BIG ROCK POINT NUCLEAR PLANT

AMENDMENT TO OPERATING LICENSE

Amendment No. 17
License No. DPR-6

ATTACHMENT TO LICENSE AMENDMENT NO. 17

FIGURE 6.2-1

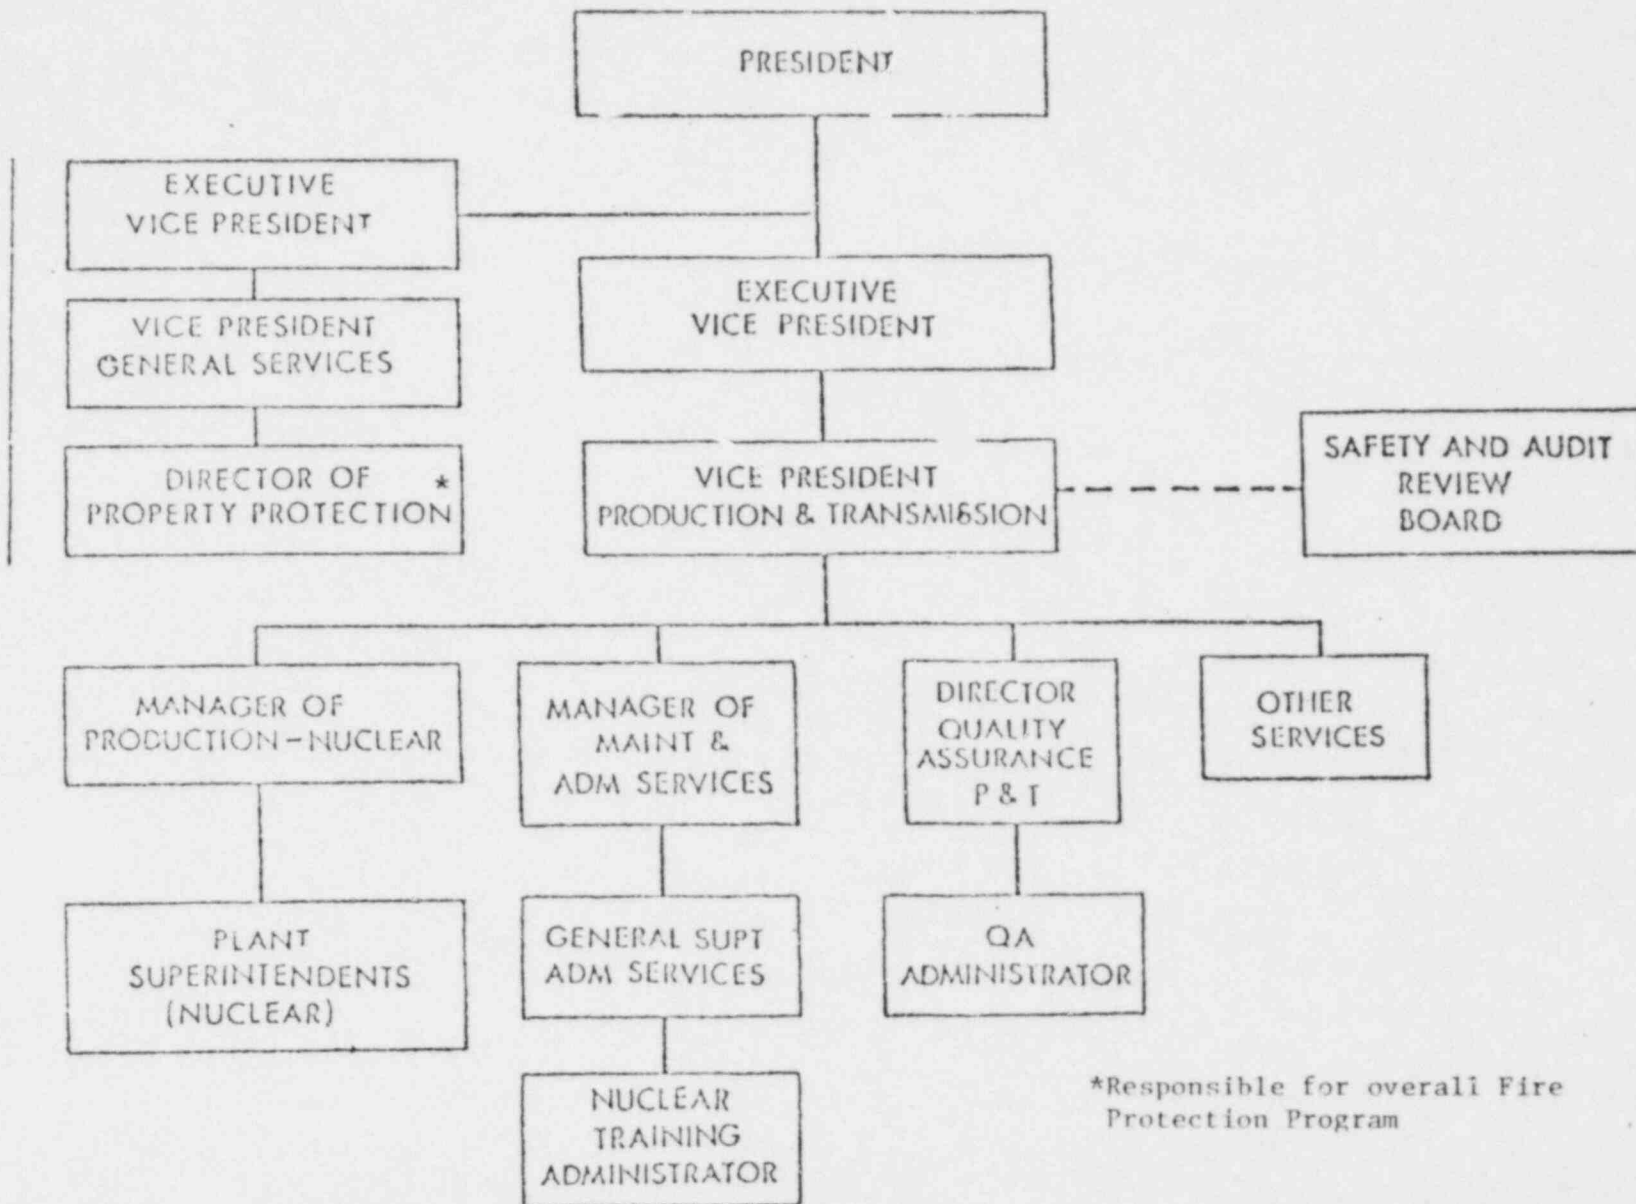
*Responsible for overall Fire Protection Program

Figure 6.2-2

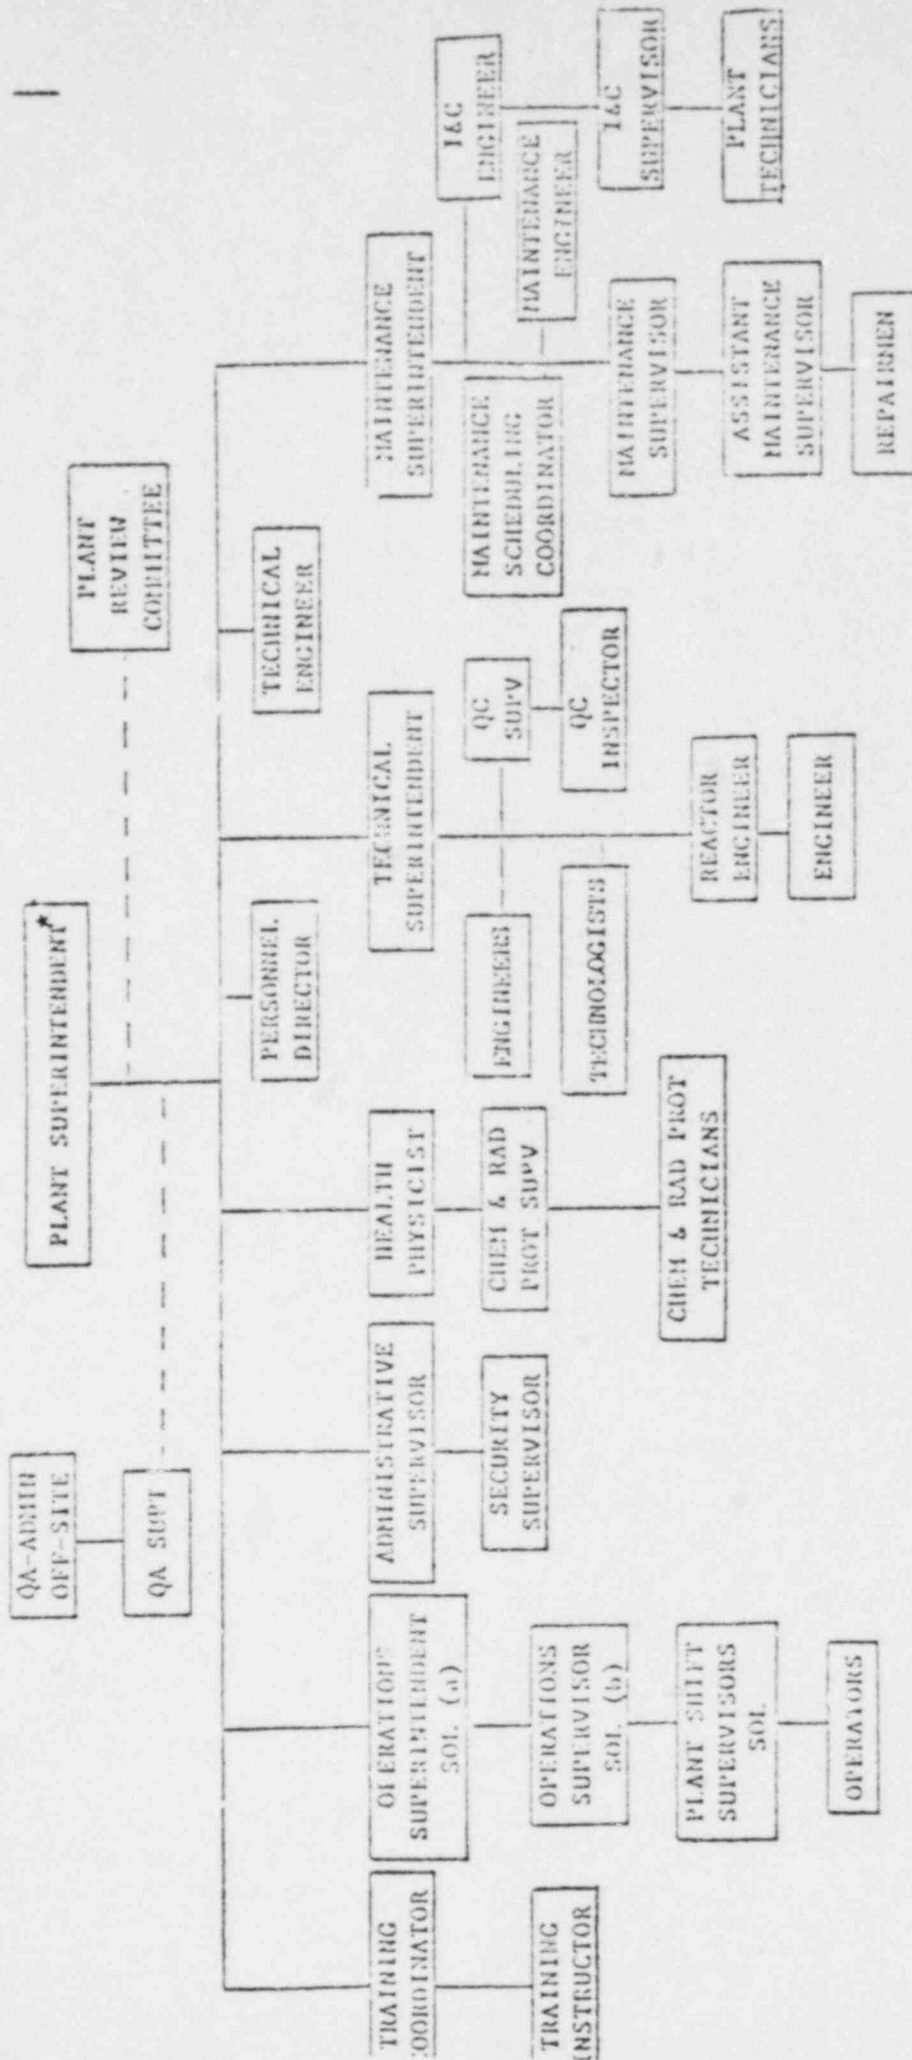
*Responsible for overall implementation of the plant Fire Protection Program.
